The Towers Condominium Association
1221 N. Dearborn Parkway
Chicago, IL 60610

- Swimming Pool Renovation – Observation / Recommendation Report

Please accept this 'Observation / Recommendation Report' as documentation associated to the existing Swimming Pool and respective filtration equipment located at 1221 Dearborn St., Chicago, IL 60010. This document includes observations made during Aquatic Design Partners' (ADP) site visit completed on Thursday 02/08/2024.

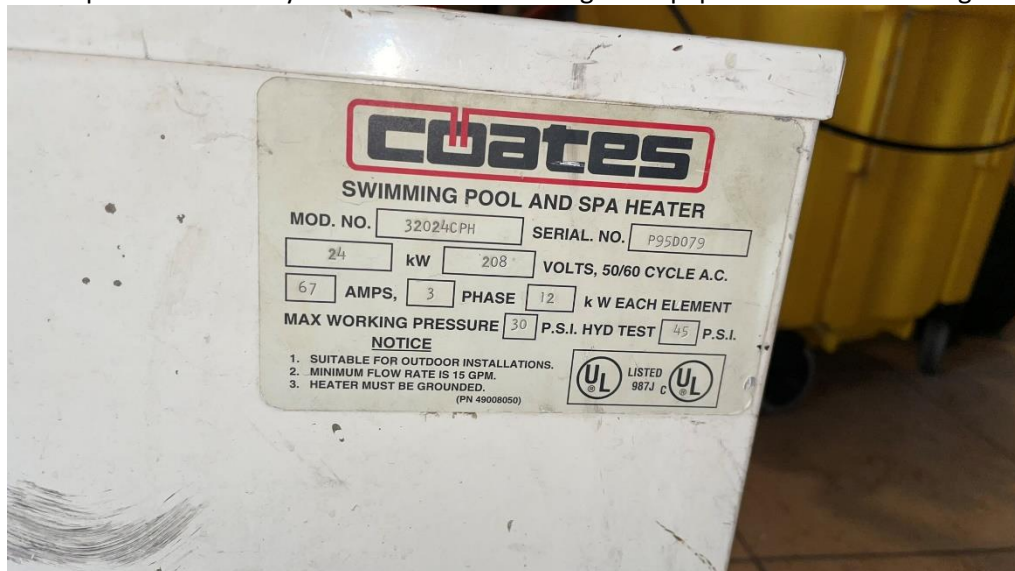
1. Observation: Swimming pool filter recirculation piping has a mix of copper, Schedule 80 PVC and Schedule 40 PVC piping:

- a)
- b) Recommendation: (C) For system flowrate consistency and ease of material availability during maintenance, it is recommended that all piping be replaced. Any new recirculation piping shall be all Schedule 80 PVC. Swimming pool heater bypass piping shall be of Schedule 80 CPVC. Pipe sizing is subject to final pool design/volume, but likely to be 3" to 2" piping.

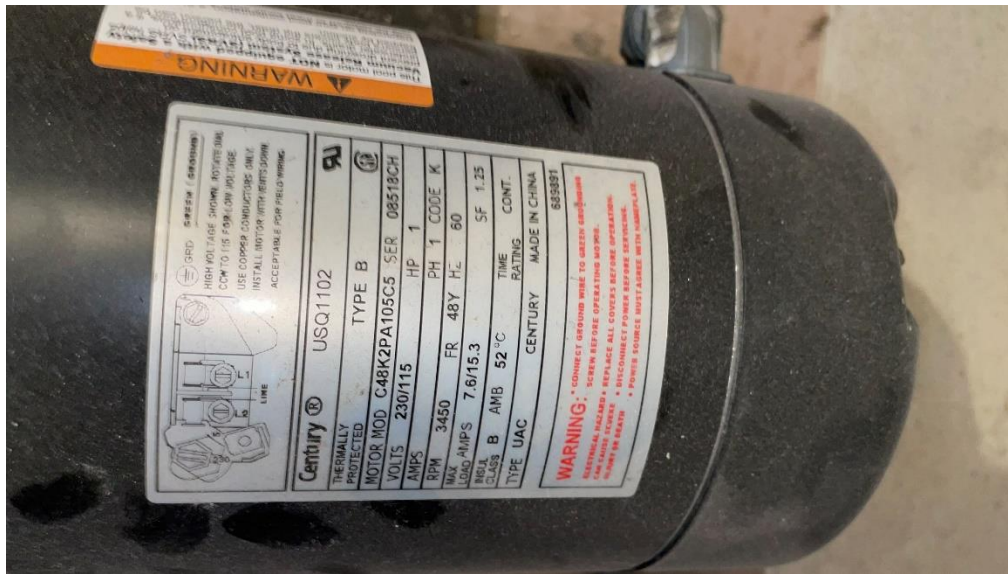
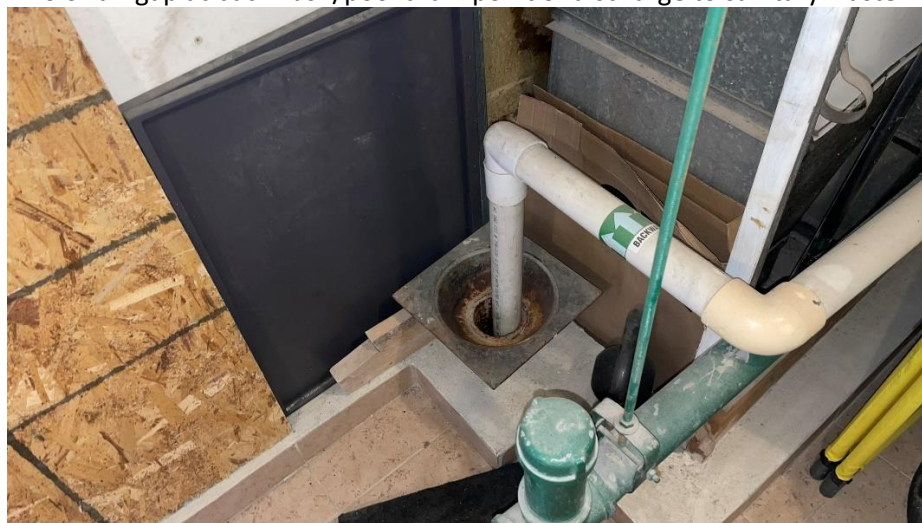
2. Observation: The existing swimming pool heater and filtration pump are assumed to be from the previous swimming pool's operational history. It is unknown how long the equipment has been sitting unused:

b) Recommendation: (C): Replacement of existing filtration pump and heater with new. Coordination with mechanical and electrical consultant required for either gas fired heater or electric heater. Long term cost savings can be gained via gas fired heater, or exchanger coordination with building HVAC system. New equipment utility load demand on existing electrical service dependent upon new swimming pool final design. To be coordinated with electrical engineer.
